CTC Elevator Lobby Study Group

10/7/2011

The following is the Study Group report that was considered by the CTC at its October 13-14, 2011 meeting. **Notes from the meeting are indicated in red.**

Draft Technical Analysis of the Need for Enclosed Elevator Lobbies

SMOKE BARRIER CONTINUITY

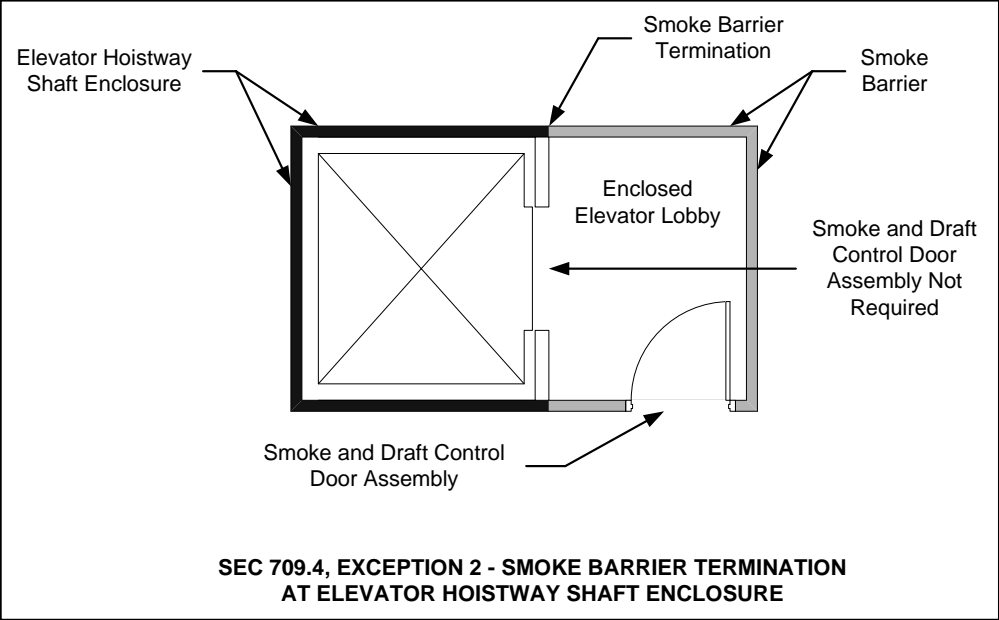
Reason: Provisions are necessary to clarify that opening protection at the hoistway opening is not necessary when an enclosed elevator lobby is provided in accordance with Section 405.4.3, 3007.7.2, or 3008.7.2. An enclosed elevator lobby protects the hoistway from smoke migration, therefore the hoistway is already protected. In addition the shaft walls provide sufficient smoke and draft protection to allow the smoke barriers to terminate at those walls.

709.4 Continuity. *Smoke barriers* shall form an effective membrane continuous from outside wall to outside wall and from the top of the foundation or floor/ceiling assembly below to the underside of the floor or roof sheathing, deck or slab above, including continuity through concealed spaces, such as those found above suspended ceilings, and interstitial structural and mechanical spaces. The supporting construction shall be protected to afford the required *fire-resistance rating* of the wall or floor supported in buildings of other than Type IIB, IIIB or VB construction.

CORRIDOR SMOKE AND DRAFT ASSEMBLY REQUIREMENTS

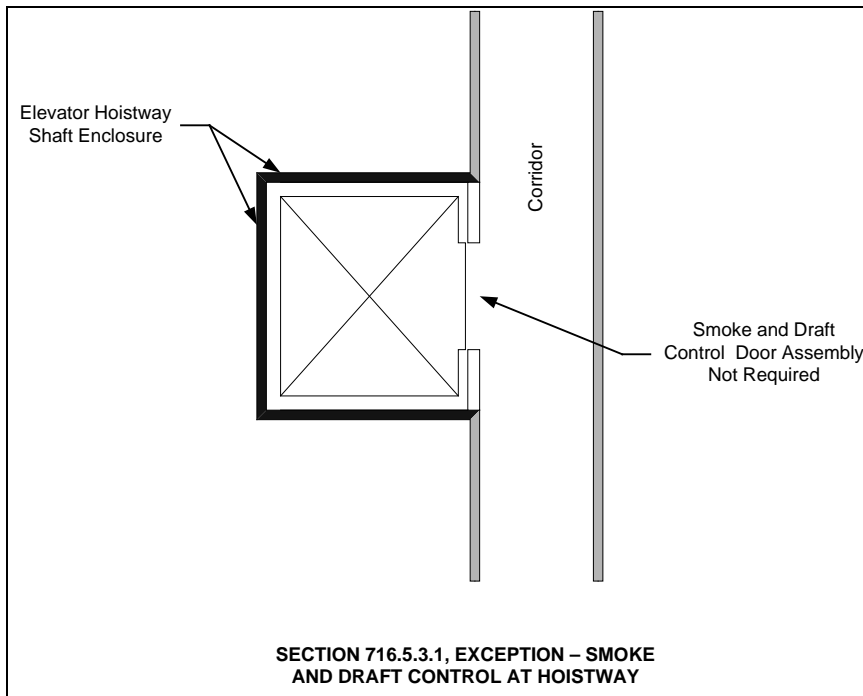
Reason: This proposal is intended to clarify that when an elevator lobby is not required in accordance with Section 713.14.1 that smoke and draft protection is not required when the hoistway opens into a rated corridor. See figure below. Section 713.14.1 is based upon number of stories and not the fact that such elevators open onto a rated corridor so it is not entirely clear how the code is currently written that this was the intent. The following are the sections that are relevant to this issue and which demonstrate how such confusion could occur. The Lobby provisions are independent from the corridor provisions. To avoid confusion on the application of this exception with the application of exception 3 to Section 713.14.1 reference has been made to the exception in 713.14.1. This makes it clear that this relationship has been considered and it was not intended to still require that exception to be applied.

716.5.3.1 Smoke and draft control. *Fire door* assemblies shall also meet the requirements for a smoke and draft control door assembly tested in accordance with UL 1784. The air leakage rate of the door assembly shall not exceed 3.0 cubic feet per minute per square foot ($0.01524 \text{ m}^3/\text{s} \cdot \text{m}^2$) of door opening at 0.10 inch (24.9 Pa) of water for both the ambient temperature and elevated temperature tests. Louvers shall be prohibited. Installation of smoke doors shall be in accordance with NFPA 105.
